**ADDENDUM NO. 2
Pioneers Blvd. Widening Project
Antelope Creek to Pagoda Lane
City of Lincoln Project No. 700019
SPEC. NO. 06-244
August 23, 2006**

ADDENDUM NO. 2
Pioneers Blvd. Widening Project
Antelope Creek to Pagoda Lane
City of Lincoln Project No. 700019
SPEC. NO. 06-244
August 23, 2006

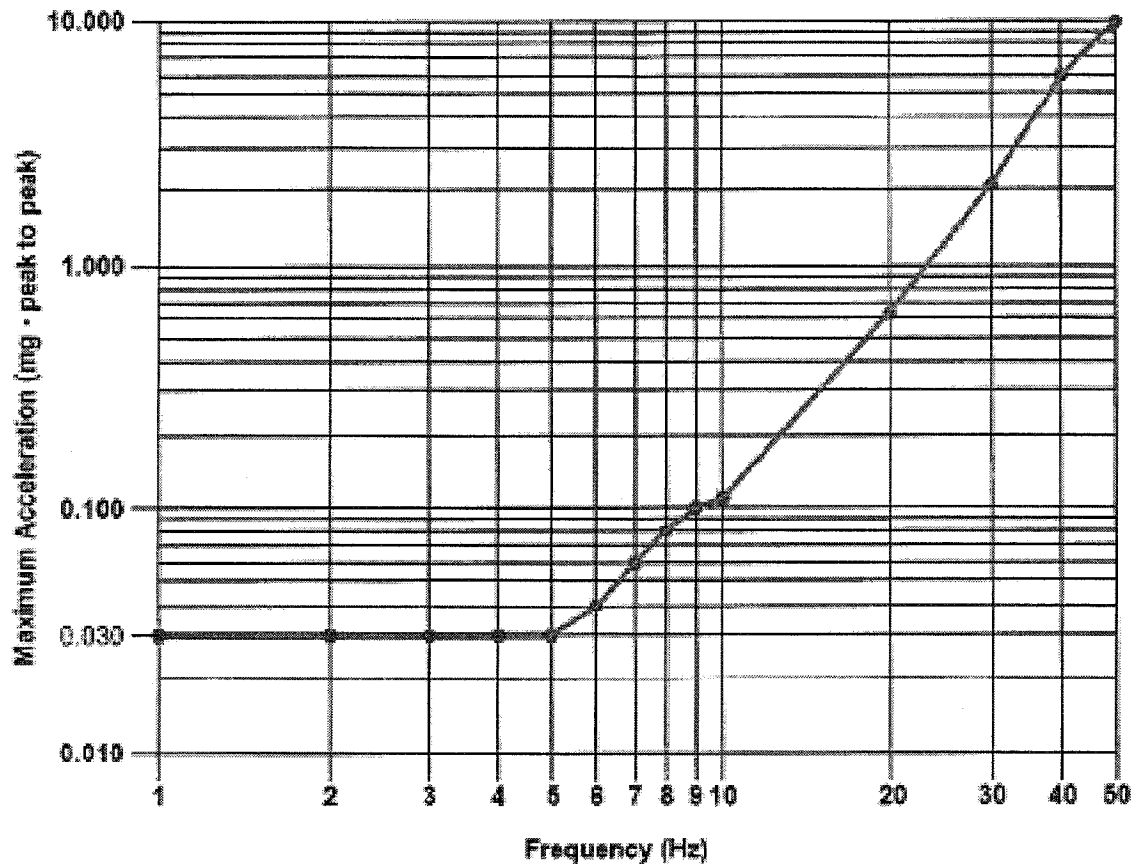
The following chart illustrates acceptable levels of coherent, or steady source, vibration levels defined by Philips, the manufacturer of the Panorama 1.0 MRI Magnet MRI machine. Non-coherent, or single-event pulse, vibrations up to 10 times the levels shown are acceptable levels of vibration once per minute.

The levels of vibration and corresponding frequencies depicted in the chart are as follows:

AMPLITUDE – ACCELERATION (mg) milli-g's

FREQUENCY	AMPLITUDE – ACCELERATION (mg) milli-g's
1-5	0.030
6	0.040
7	0.060

8	0.080
9	0.100
10	Approx. 0.110
20	0.600
30	2.000
40	6.000
50	10.000

CITY OF LINCOLN, NE (2006)
PIONEERS BOULEVARD
WEST OF ANTELOPE CREEK TO PAGODA LANE
WIDENING PROJECT #700019

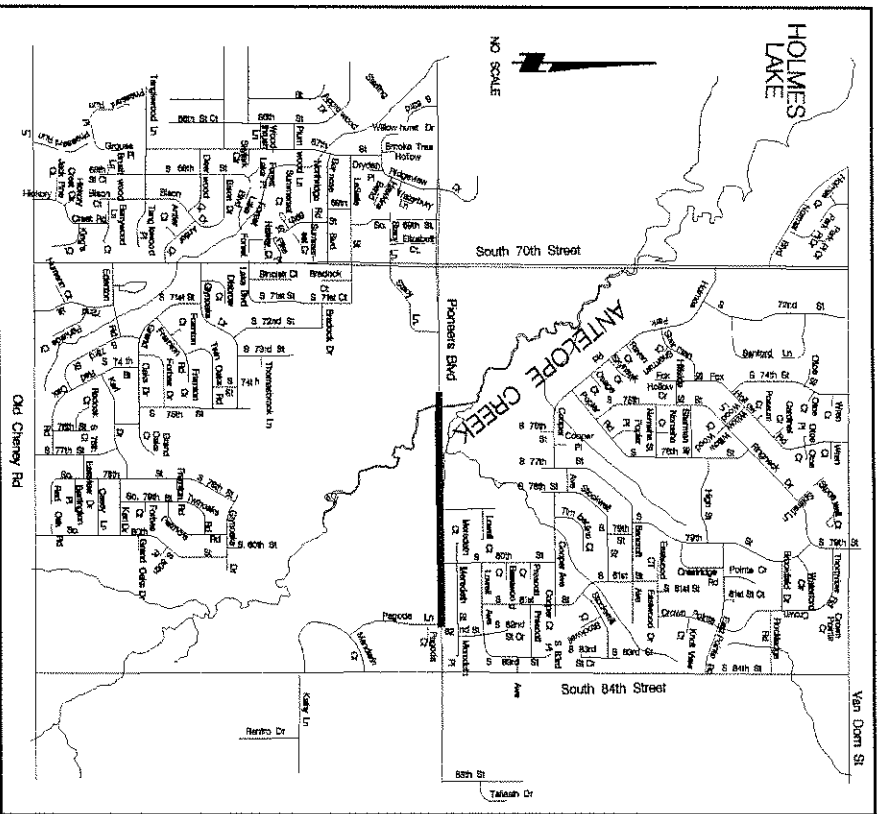
Rev. No.	Date	Sheets Revised
R	08-08-06	2, 7, 10, 11, 14, 15, 37, 50, 52, 59, 72
12	08-23-06	2

The quantity for item 15.0010 Class 47B-3000 for Bridge in Group 15 has been modified from 147.60 C.Y. to 180.0 C.Y. Attached is the updated Project Item Schedule reflecting this quantity modification for the item.
